# URGENT MEDICAL DEVICE CORRECTION

July 14, 2025

Baxter is issuing an Urgent Medical Device Correction for the **Novum IQ** large volume pump (LVP) due to the following two issues:

Figure 1

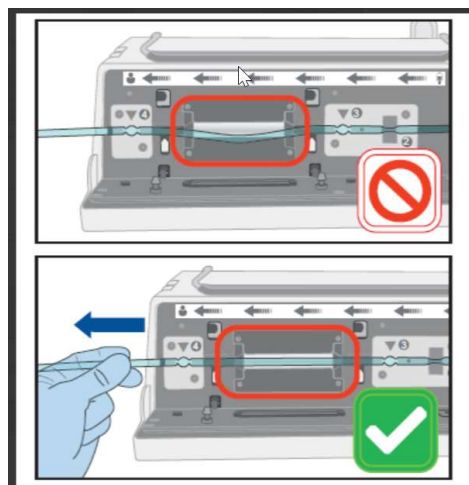
- 2) Baxter has identified an increase in customer reports of over and underinfusion that may be due to set misloading. Failure to properly load the tubing into the pump channel may result in the pump infusing at a rate higher or lower than programmed. Consistent with the instructions for use, customers should ensure that:
  - a) The door is fully open before loading the set as pictured on page 5 of enclosed Attachment A.
  - b) The tubing is taut and loaded without slack in the pumping channel as pictured on page 7 of enclosed Attachment A, and in Figure 1 below.

Baxter is developing a hardware change to reduce misloading of the set and will contact customers to update the pumps when the correction is available.

3. To prevent misloading, please follow the instructions for loading the set in section 4.3, Loading an Administration Set, of the **Novum IQ** LVP Operator's Manual (refer to enclosed Attachment A).
